# Indoor Station Firmware V2.2.20\_build230601

## Release Note (2023-06-06)

Device Model	DS-KH8350-WTE1, DS-KH8350-TE1, DS-KH6320-WTE1, DS-KH6320-TE1, DS-KH6320Y-WTE2, DS-KH6320EY-WTE2, DS-KH6320-WTE2(B), DS-KH8520-WTE1, DS-KH6320-WTDE1, DS-KH6320-TDE1
Firmware Version	V2.2.20_build230601
iVMS-4200	V3.9.1.4 or later

B. Link indoor station with main and sub door station

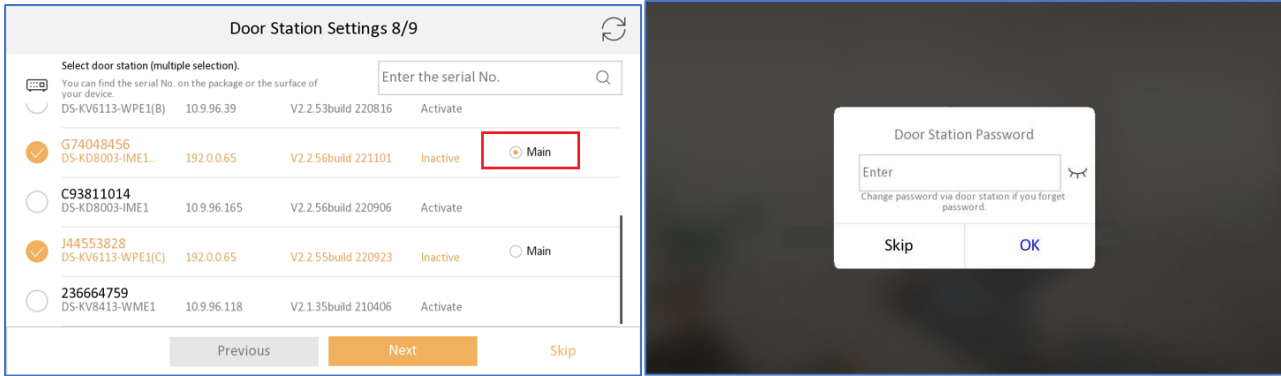
- the first selected will be the main door station by default, the second will be sub1, 3<sup>rd</sup> will be sub2, etc. You can also cancel and select the main door station manually.*
- Maximum select 17 door stations at one time (1 main and 16 sub door stations)*
- If the selected devices are not activated, indoor station will activate them with same activation and registration password, then set the IP address for them in same network segment automatically.*
- If the door station is already activated with different password, it will prompt you to input door station password*
- If the main and sub door station are activated with different activation password, the registration will be failed (sub door station can't call indoor station).*

### C. Link indoor station with indoor extension

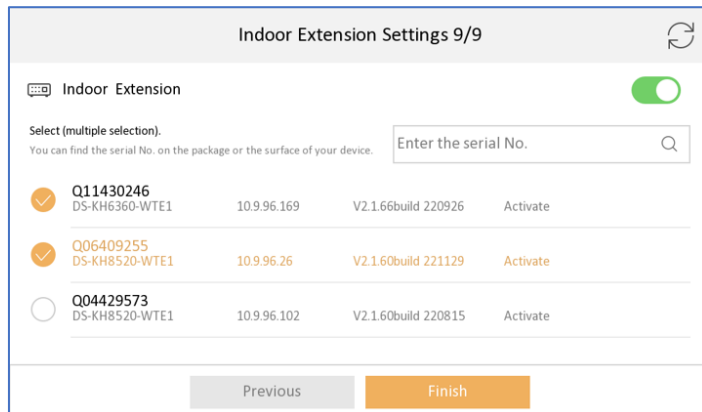
- a. The selected indoor station will be and numbered as indoor extension 1,2,3...
- b. Maximum select 5 indoor extensions at one time
- c. If the selected devices are not activated, indoor station will activate them with same activation and registration password, then set the IP address for them in same network segment automatically.
- d. If the selected devices are activated with different password, the registration will be failed (door station can't call indoor extension).

### D. Pairing with main door station, sub door station and indoor extension

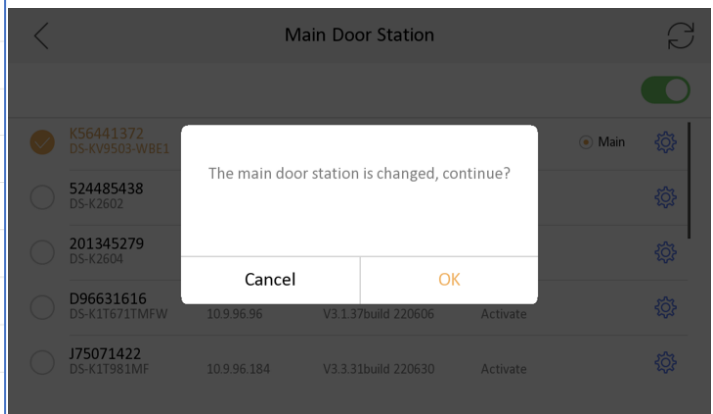
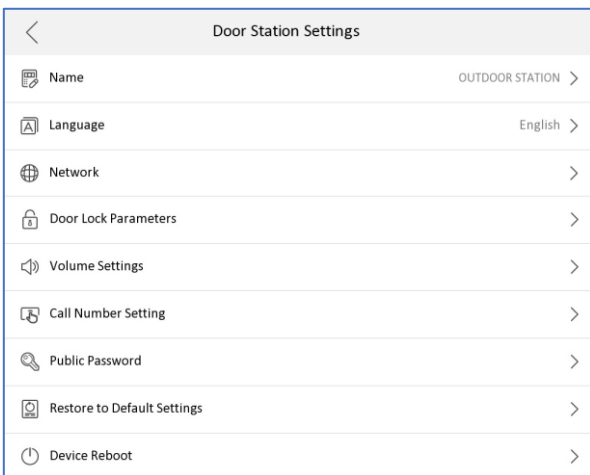
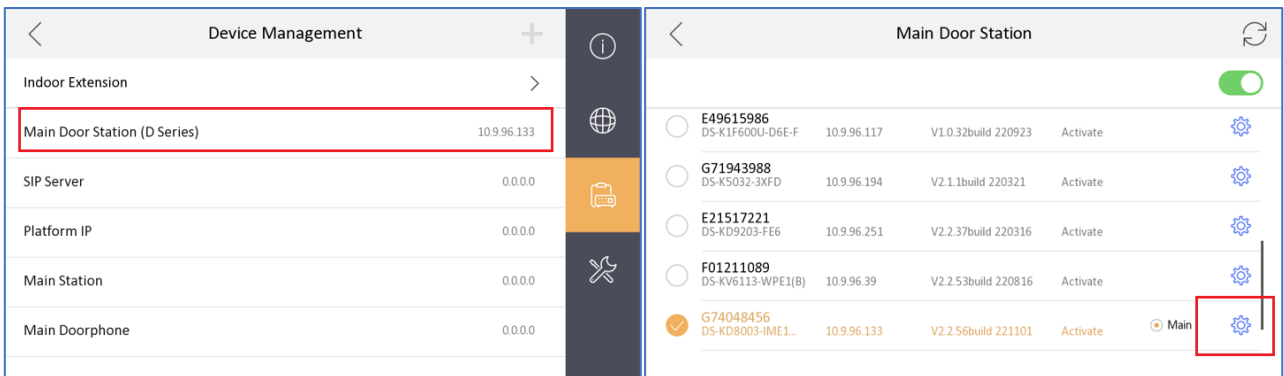
**Note:** The pairing time duration depends on the device quantity you selected in previous steps, it will take about up to 5 mins, please wait patiently until the process finish and show "Configured" as below.

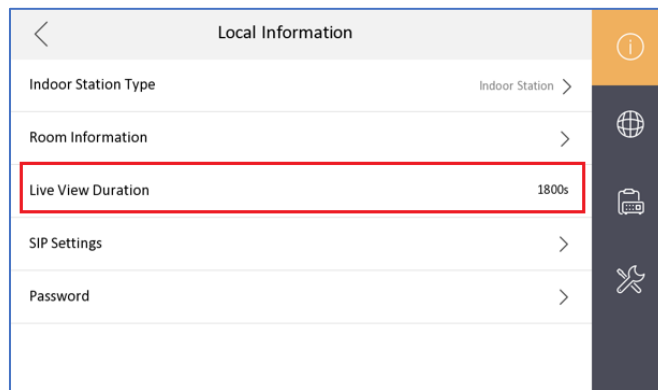
1. Optimized the icon of door station registration status in the main UI up right corner.

*Note:* If the door station call indoor station failed, you can click this icon  to register to door station manually, if register failed, it will indicate the reason for the failure.

Before	Now
Indoor station registers to door station success		
Indoor station registers to door station failed		
Indoor station registers to door station and KM9503 success

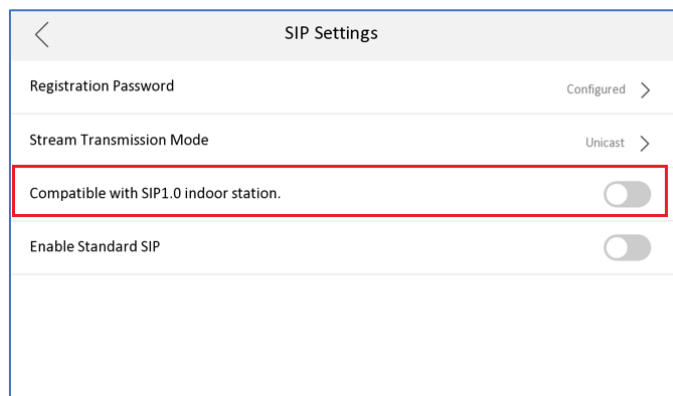
3. Support switching between protocol 1.0 and 2.0, by default it's protocol 2.0  
After enable, the indoor station is compatible with protocol 1.0 indoor extension and not compatible with protocol 2.0 indoor extension.

*Note: After enable, all indoor extension of this indoor station must be protocol 1.0 firmware, don't mix protocol 1.0 and 2.0 indoor extension under same indoor station, or it will result to calling failed.*

## Wizard-Indoor Station Settings 3/5

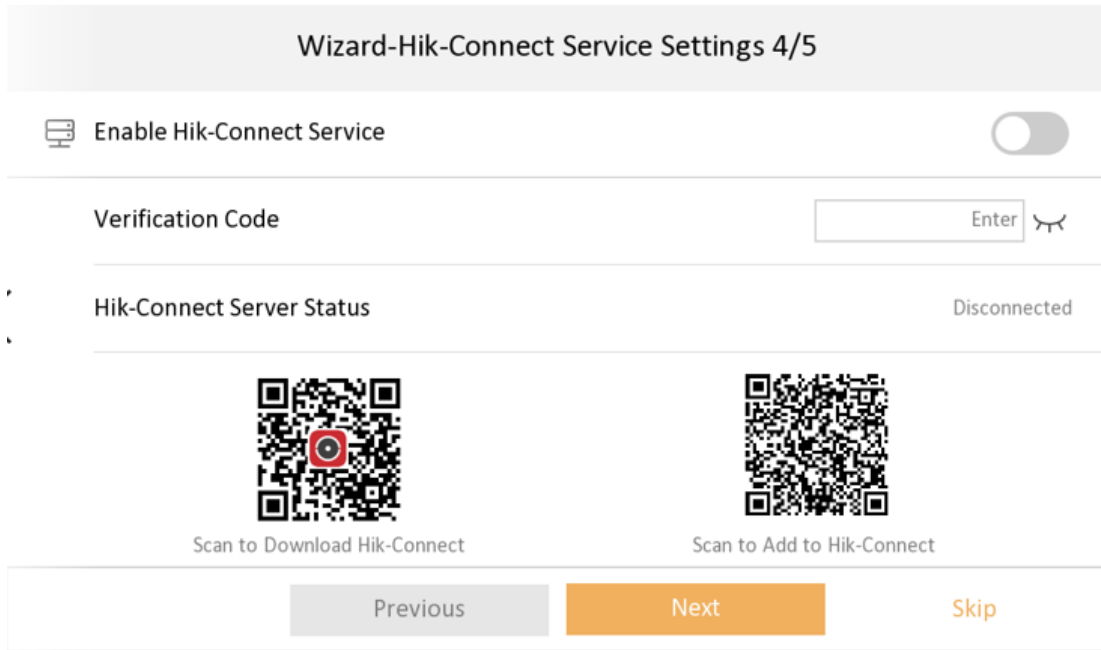
1. Optimize registration password settings in Wizard.

**Wizard-Hik-Connect Service Settings 4/5**

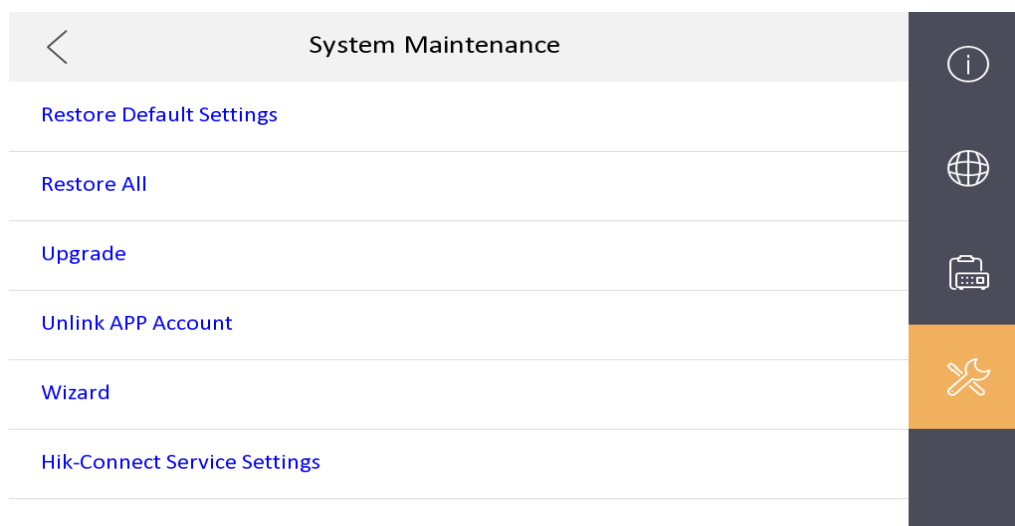
1. Verification code is empty by default.

- Hik-Connect Service Settings is changed to the place of Settings→ Advanced Settings→ Configuration→ System Maintenance.

**Add Device**

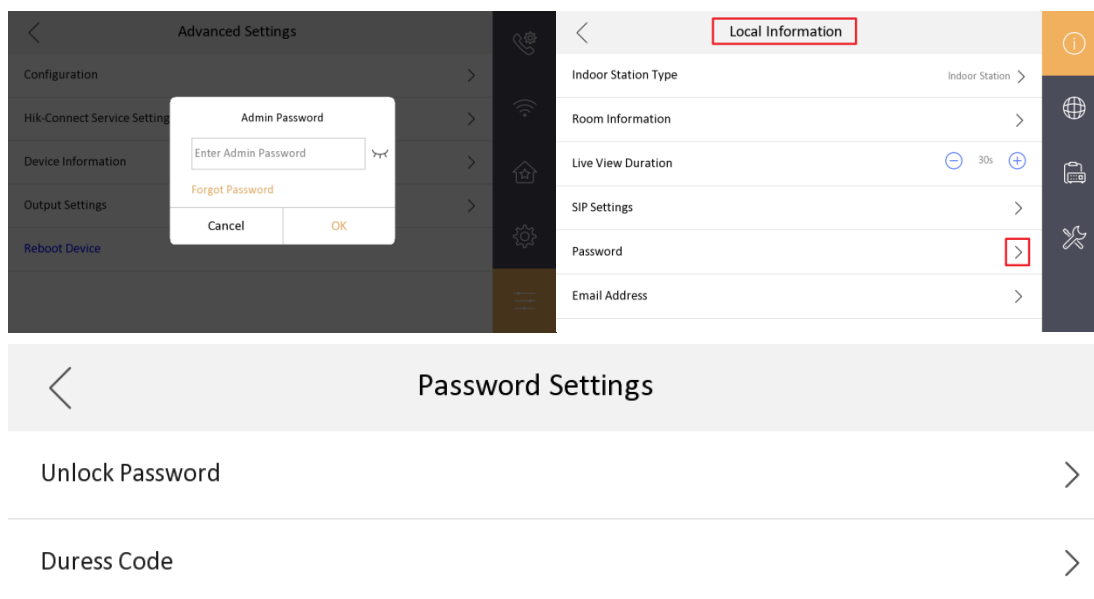
4. Add IPC interface, when Open Network Video Intercom protocol is selected, add plaintext ciphertext switch menu item configuration
